UNITED STATES
NUCLEAR REGULATORY COMMISSION
WASHINGTON, D. C. 20555

The NRC Uranium Recovery Licensing Branch has received and reviewed the information Teton Exploration Drilling Company, Inc. (Teton) submitted in response to Condition No. 32 of the Source Material License issued (license number SUA-1373) for uranium in situ extraction operations at the Leuenberger site. The submitted information concerned the design, construction and testing of the Leuenberger site evaporation pond embankment. Since the pond wastes will be similar in composition to wastes in tailings ponds, the Leuenberger embankment was evaluated to determine its conformance to the design of tailings pond embankments described in NRC Regulatory Guide 3.11. A copy of Regulatory Guide 3.11 is enclosed.

ENCLOSURE 2

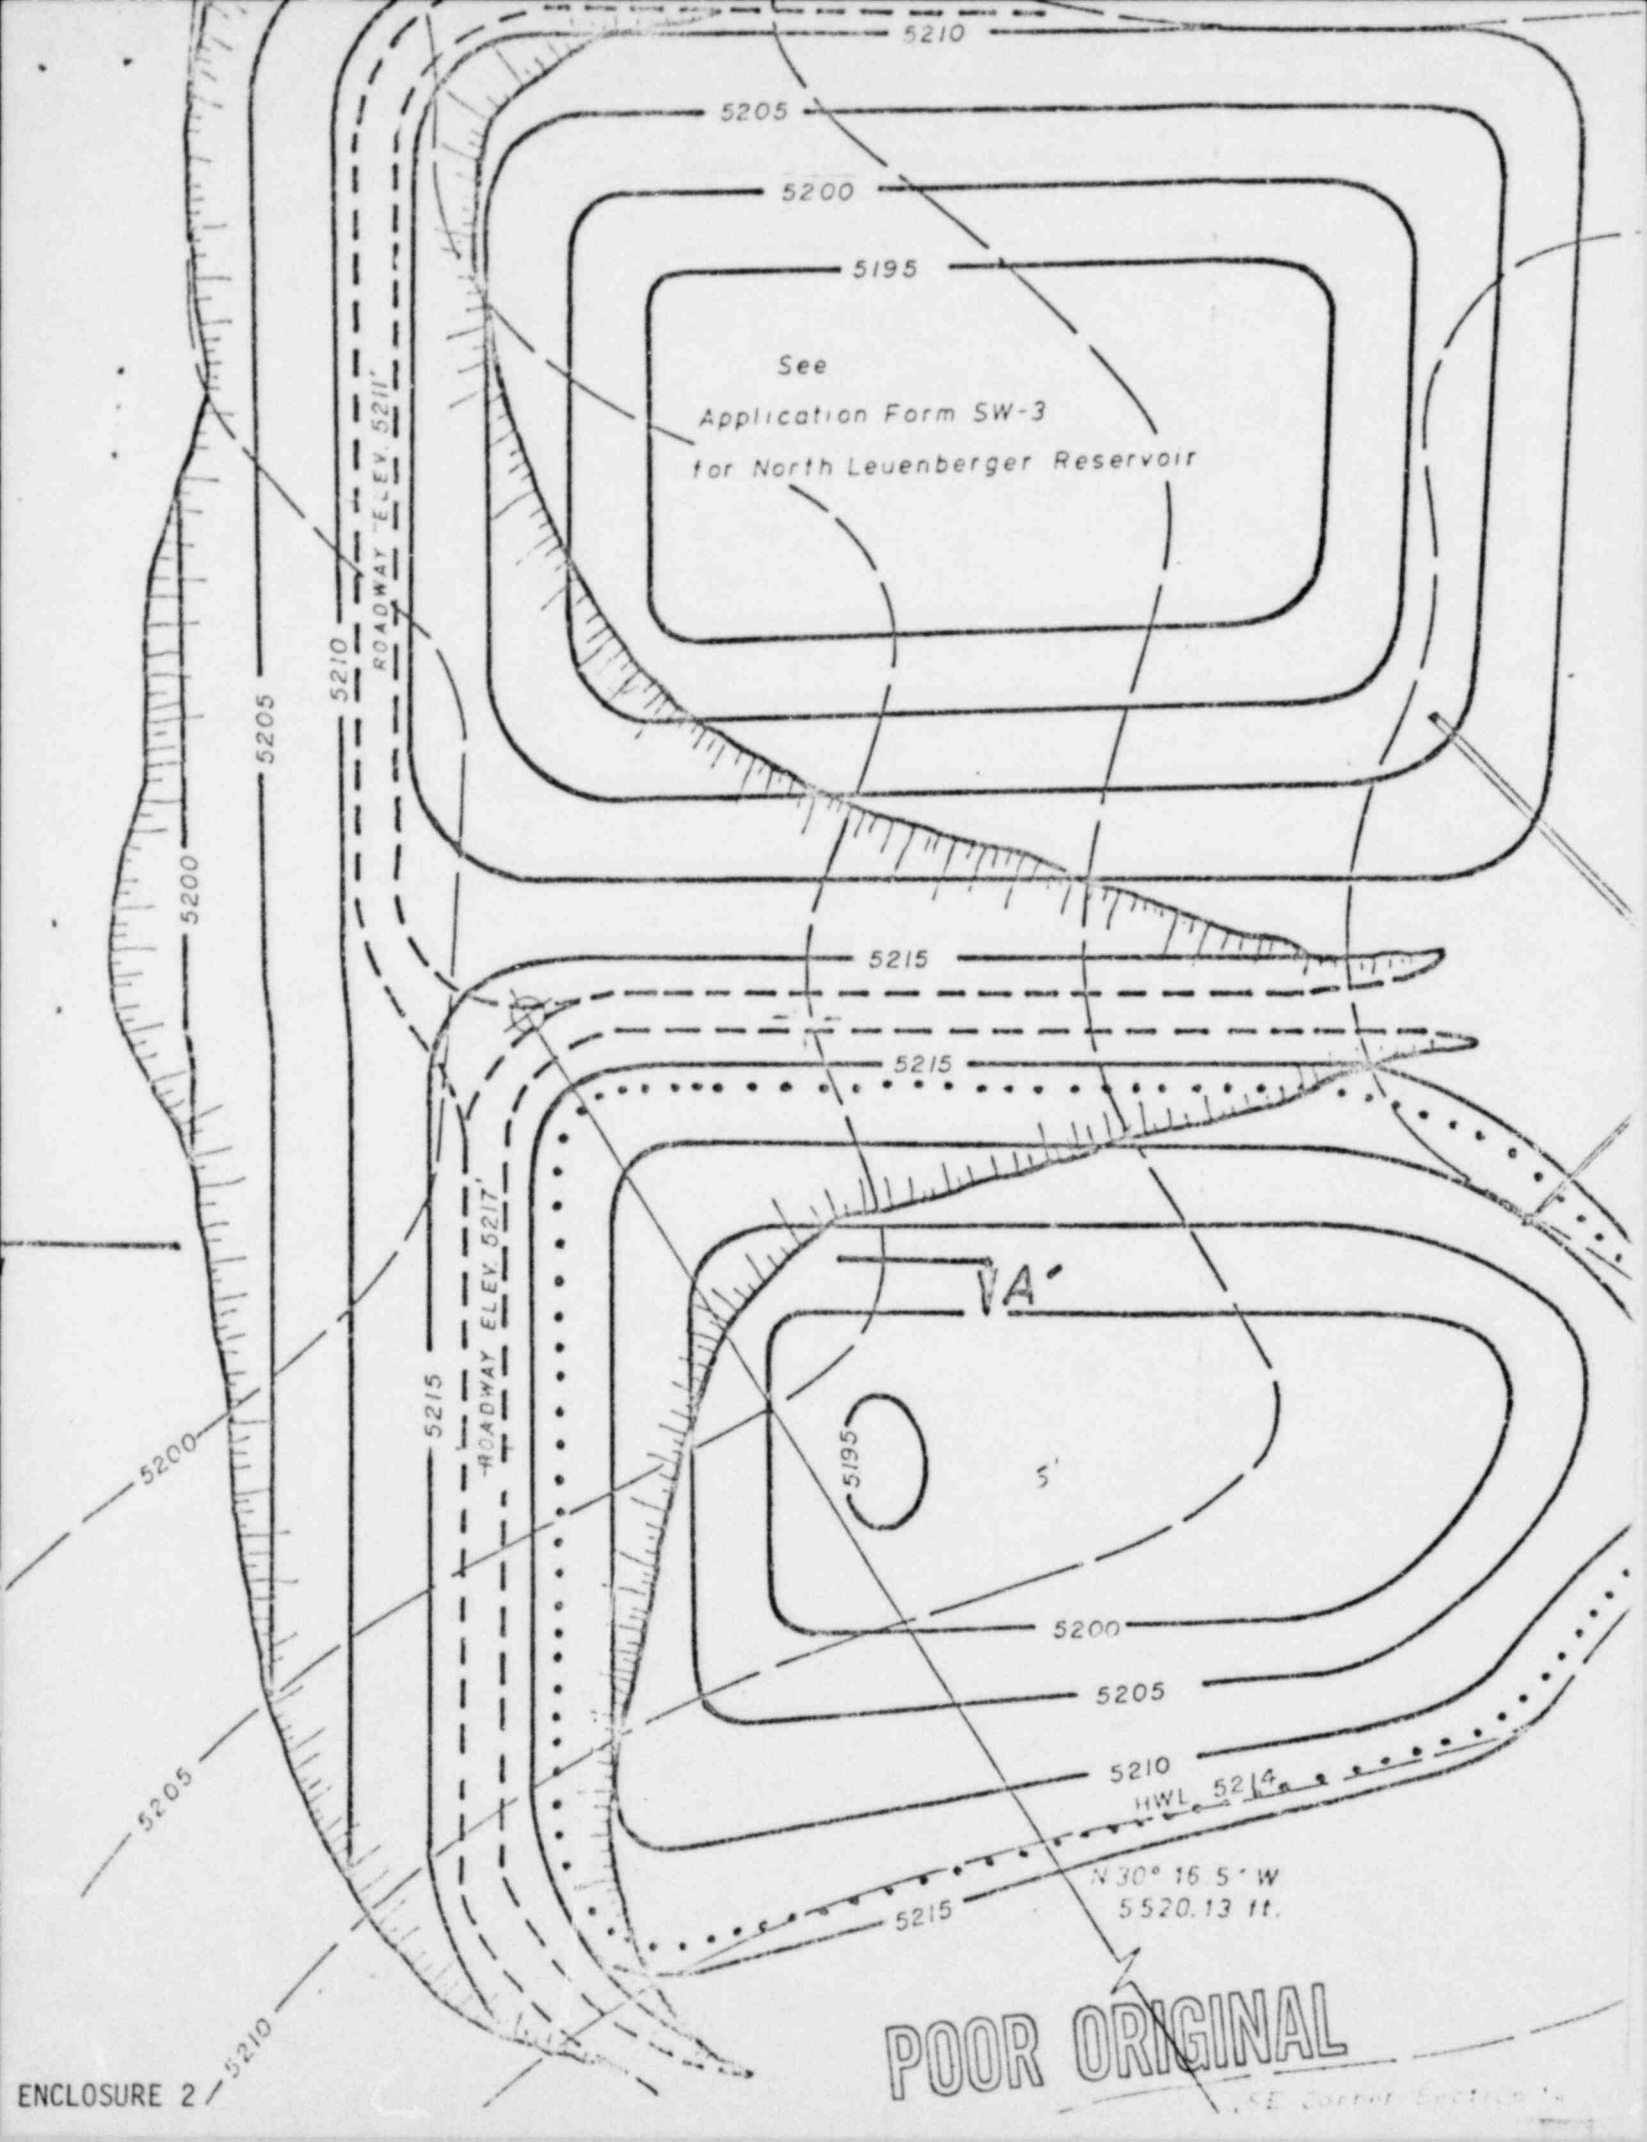
2. Three (3) borings should be drilled at approximately the locations shown on the attached figure. The borings should extend through the embankment and then a minimum of 15 feet into natural foundation materials, and should not be terminated in weak or highly compressible or loose soils. Continuous sampling (disturbed or undisturbed) should be performed in the three borings in order to assess the strength characteristics of the embankment and foundation materials. Disturbed sampling of soils should be with split-spoon sampler and hammer and conducted in conformance with the Standard Penetration Test Procedure (ASTM D 1568-67). Undisturbed samples should be at least 3 inches in diameter and should be obtained with a suitable fixed piston-type, thin-wall tube sampler (ASTM D 1587-67) or method that yields undisturbed samples of equivalent quality.
